平成 25 年 5 月 23 日
資源エネルギー庁

国際原子力機関(IAEA)による東京電力(株)福島第一原発1～4号機の 廃炉に向けた取組についてのレビュー結果を公表します

IAEA レビューミッションの報告書における主要な助言

Fig. 1. Waste management planning methodology

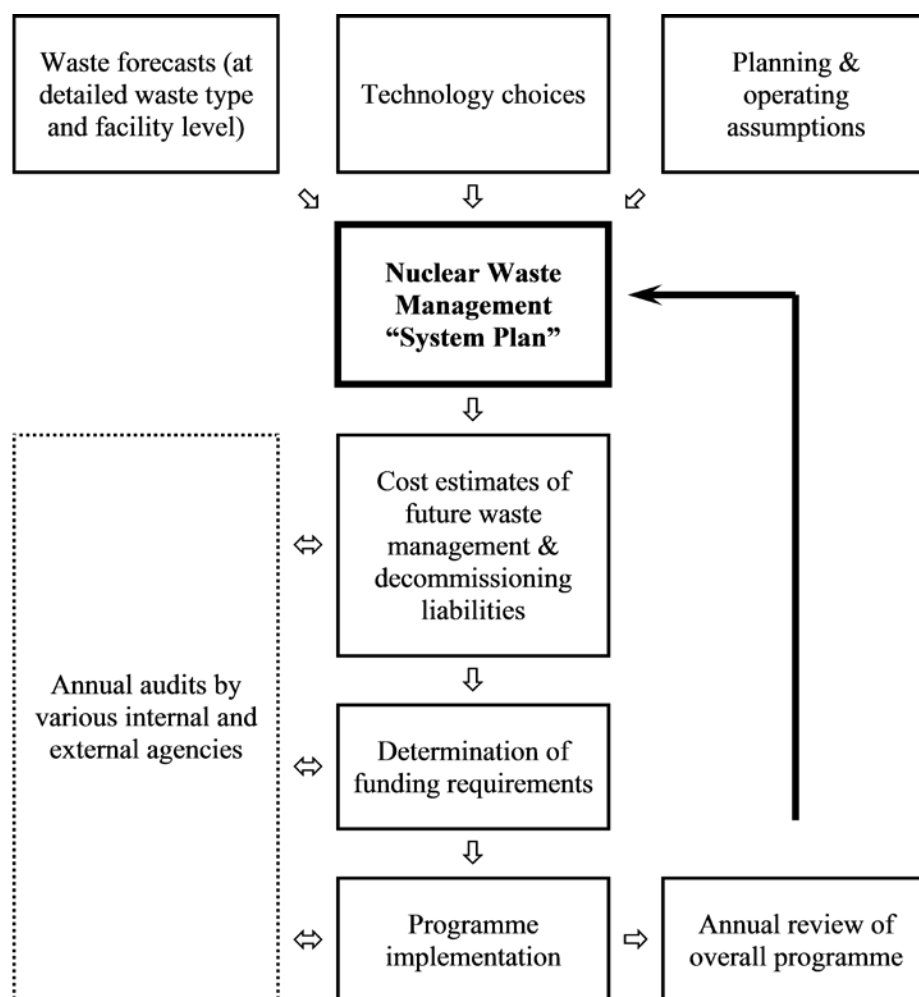
Identification of waste types and generation rates that can be attributed to baseline technical options and alternatives that might be pursued during decommissioning is prerequisite for having TEPCO's strategy and long term plan for the waste management. Taking into consideration that effectiveness and associated costs of waste management are major contributors to the success of decommissioning, the long-term waste plan could be used as a tool to optimize baseline technical options and alternatives identified by the *Roadmap*. Engineering estimates of alternatives and associated costs would also allow identification of different waste management scenarios that should be considered during the decommissioning project and eventually optimized with timely deployment of cost effective technologies, processing and storage facilities on and off the Fukushima Daiichi NPS site. Work on long-

term planning should start with rough estimates of volumes, types and characteristics of different waste streams for all phases identified by the *Roadmap* for decommissioning Fukushima Daiichi NPS, even though end-points for waste have not yet been defined.

The execution of efficient waste management means full understanding of the task or more detailed knowledge of waste inventory tracking, forecasting and planning. The regular updates of inventory are required for all of current and future radioactive waste and spent fuel and fuel debris management options. Such updates are used to estimate and confirm the adequacy of funds required to pay for these future liabilities as well as to plan for future waste management needs. The overall methodology that could be used is illustrated with Fig.1.

The IAEA team encourages TEPCO to start preparing its strategy and long-term waste management plan by estimating volumes, types and characteristics of different waste streams and by identifying optimized waste management scenarios for all phases identified by the Roadmap for decommissioning Fukushima Daiichi NPS, even though end-points for waste are not yet defined.
